**AGENDA FOR REGULAR MEETING  
VILLAGE OF TINLEY PARK  
PLAN COMMISSION  
August 20, 2015 – 7:30 P.M.  
Council Chambers  
Village Hall – 16250 S. Oak Park Avenue**

**MINUTES OF THE PLAN COMMISSION**  
**VILLAGE OF TINLEY PARK,**  
**COOK AND WILL COUNTIES, ILLINOIS**  
**AUGUST 6, 2015**

# PLAN COMMISSION STAFF REPORT

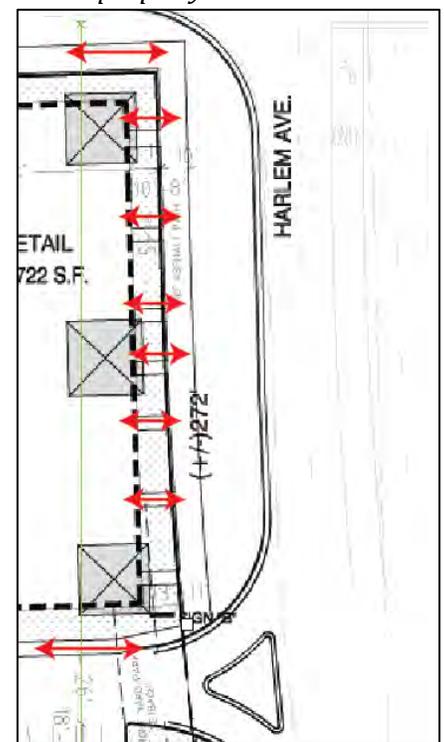
***Open Item #2: Due to engineering concerns the right-out egress lane on 191<sup>st</sup> Street will be eliminated upon provision of cross access to the west or south. This will be addressed in the Development Agreement.***

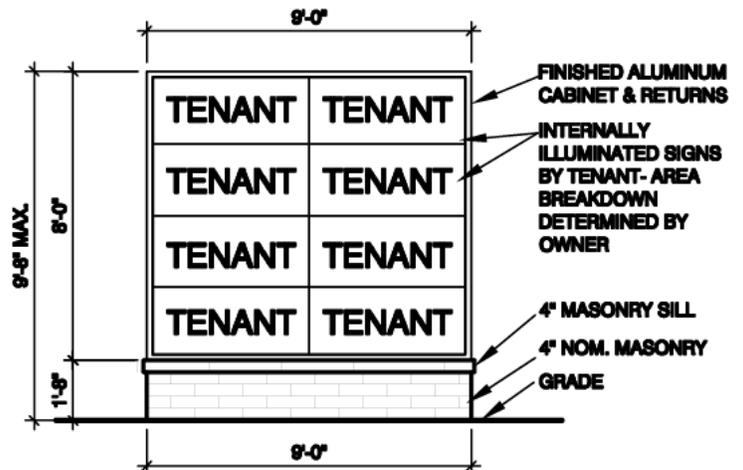
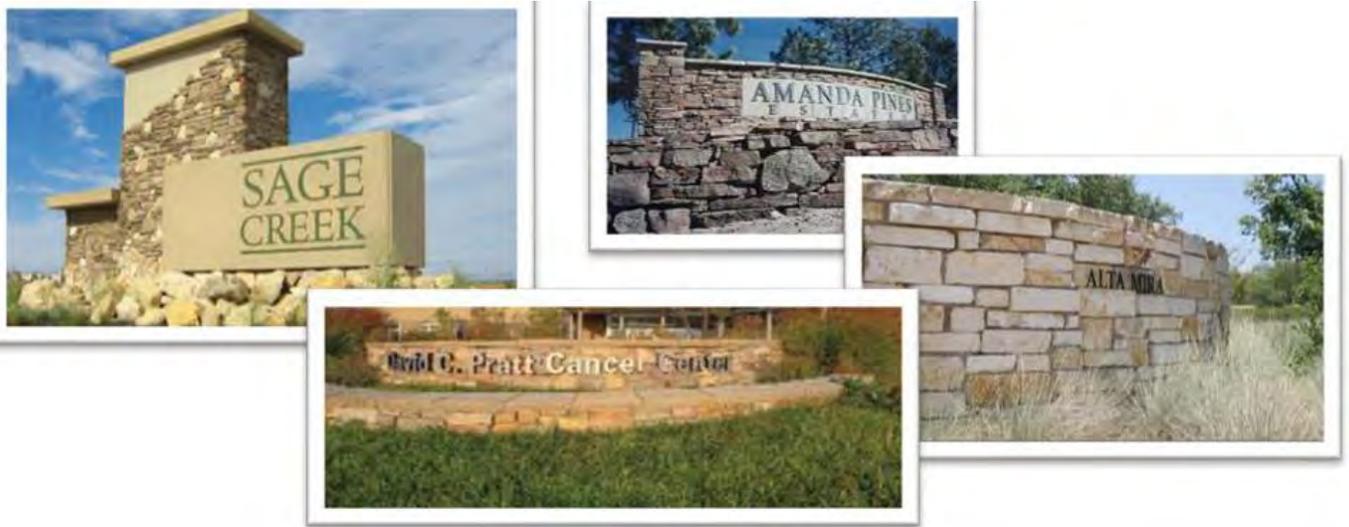
***Open Item #5: Minor landscape design and plant choice issues need to be addressed; location of street trees needs to be determined and conflict between cross access easement and trees must be resolved. Applicant will provide a revised landscape plan. A cash in lieu payment for the balance of the street trees will be addressed in the Development Agreement.***

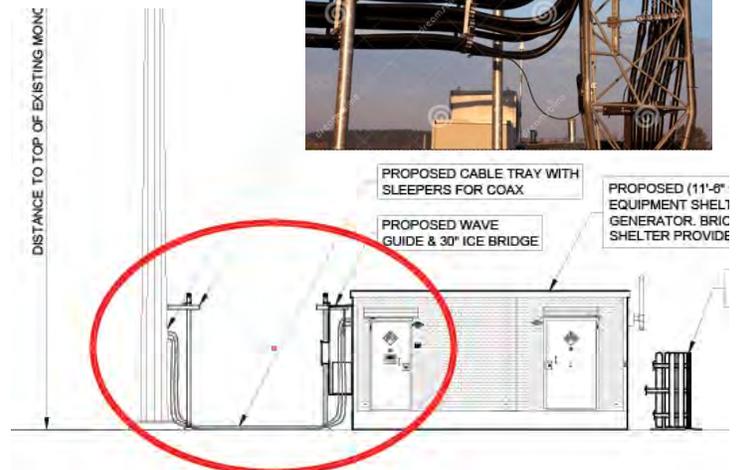
There are three (3) wall mount lights proposed on the shelter. Two (2) are on the south façade and one (1) on the north façade. Neither of these façades directly face residential property. The light is designed to shed light in a downward direction and is operated by a photocell. No photometrics have been provided, however the fence will provide some screening of the light fixture. The light is proposed to be mounted at a height of approximately 9' from the ground elevation. Staff recommends the light fixture be mounted on the structure at a height of 6' or less. PICTURE

**Open Item #5:** Provide Photometrics or install the wall mounted light at an height lower than the adjacent fence. Wall mounted light will be installed at a height of approximately 9' on the prefabricated shelter.

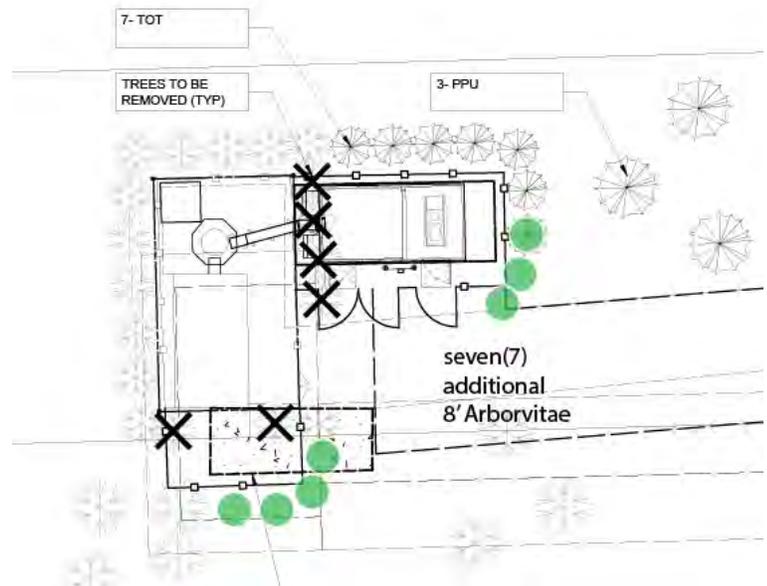
***Open Item #6: The Applicant has requested the use of an ice bridge. Applicant will provide a modified ice bridge as illustrated above.***

**2** ELEVATION-EQUIPMENT ENCLOSURE  
 SCALE: 1/2" = 1'-0"

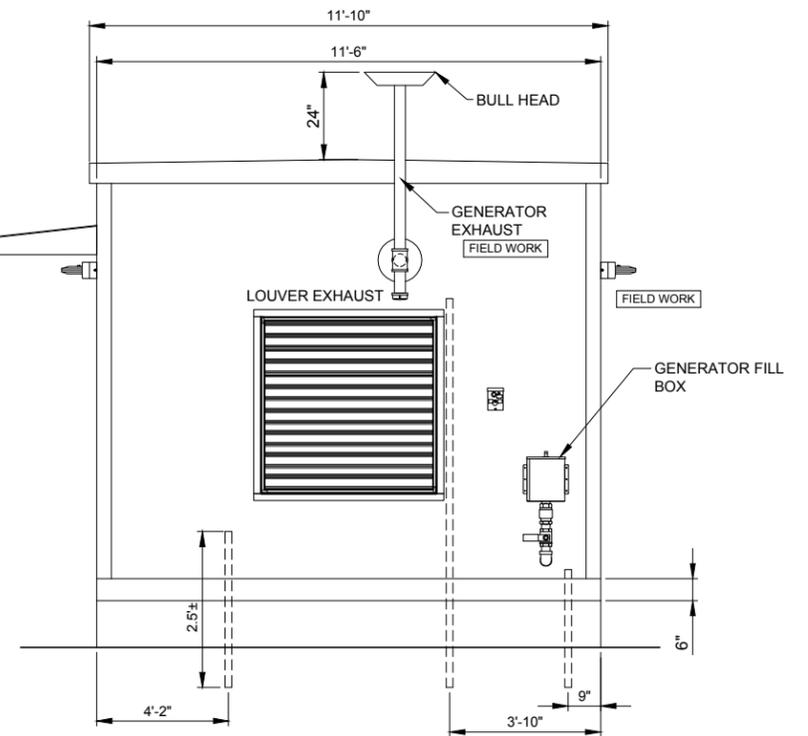
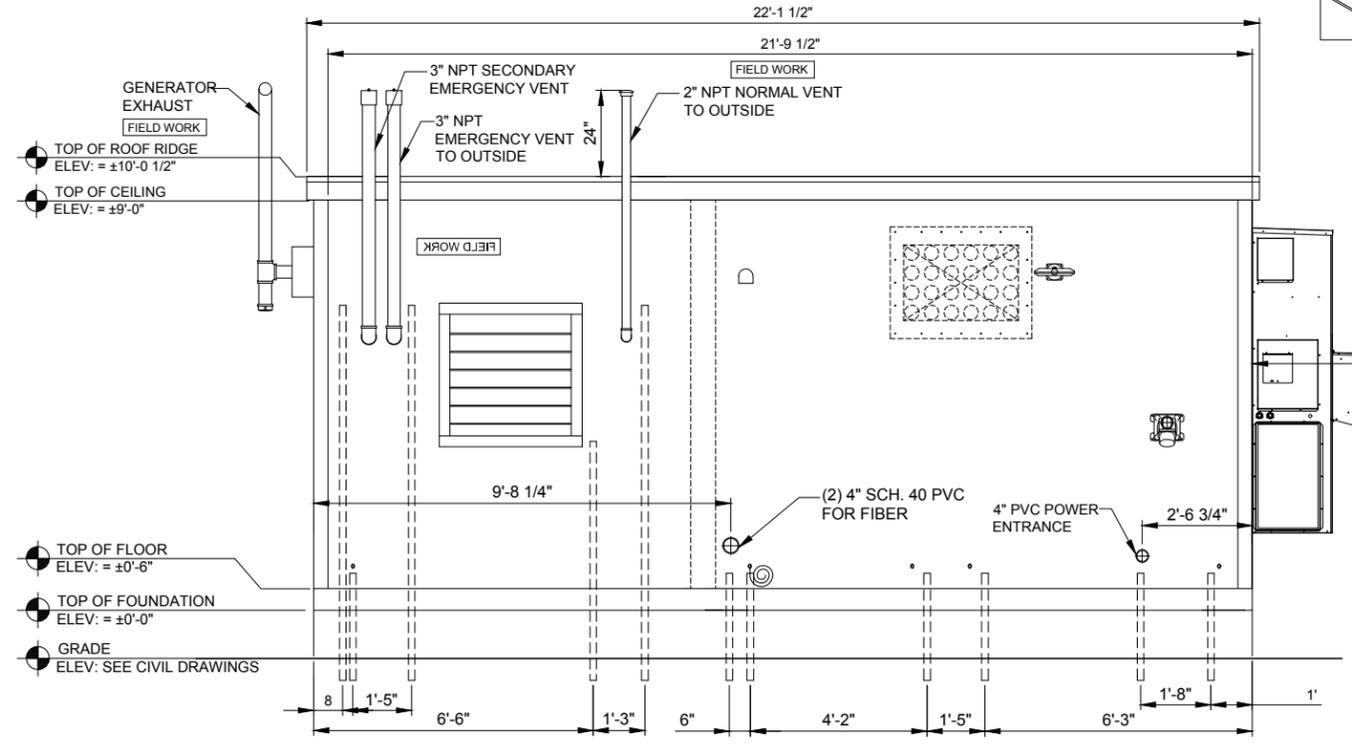
**NOTE:**  
 ALL SHELTER LIGHTS  
 TO BE SHIELDED

**NOTE:**  
 SHELTER REQUIRES  
 BRICK FACE
